## ***OSD Object Fencing Changes to r09***

David Nagle, Panasas, Inc.

### ***Enabling Revocation of Object Access in OSD R9***

**Figure 4 — OSD security model transactions**

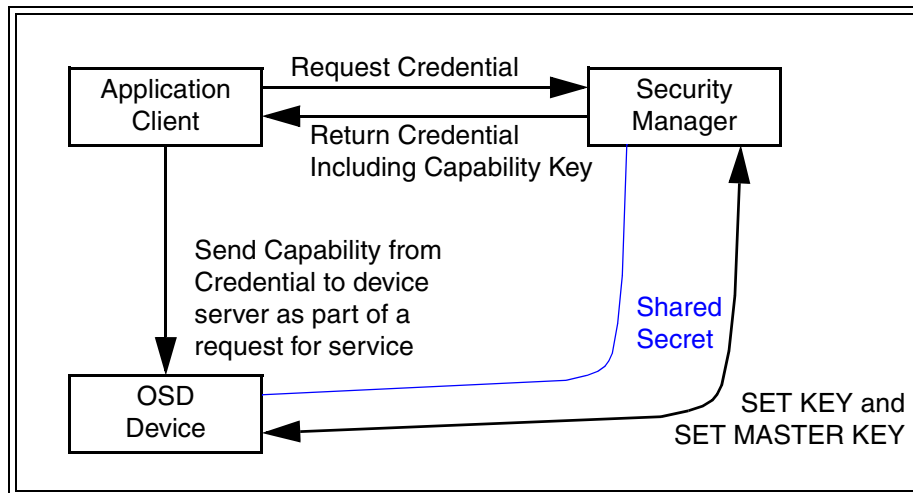
More importantly, commands that do not include a capability completely circumvent the object-access revocation mechanism designed into the OSD model with the use of an object-version number (called the SECURITY VERSION TAG in v9 of the OSD spec). Revocation of access to an object is not a security issue, it is a coherence issue that distributed systems require to ensure correct functionality (see XXX for a full description of the history and use of access revocation in the OSD model).

Therefore, it is important to separate the notion of security from the OSD capability. Specifically, we recommend that capabilities be attached to all commands, regardless of the security level. The major change is that NOSEC level would still require a capability to be sent on every command. However, the capability would not be signed and no signature checking would be performed at the OSD. Of course, this leaves open the possibility that rogue clients could tamper with a capability. However, in the NOSEC model, clients are trusted not to tamper with the capability. However, it is essential that the manager, client and OSD exchange capabilities so that managers can enforce file system policies, including read/write access and coherence.

1. A statement about object-fencing, describing that an OSD must increment the object version number when the OSD detects object damage.
2. A Capability-based permission bit that allows commands to modify the object version number
3. Security level NONE should provide a capability, but will not be signed.
  - a. Remember that a capability is permission. Security only enters into the picture when the capability is signed.
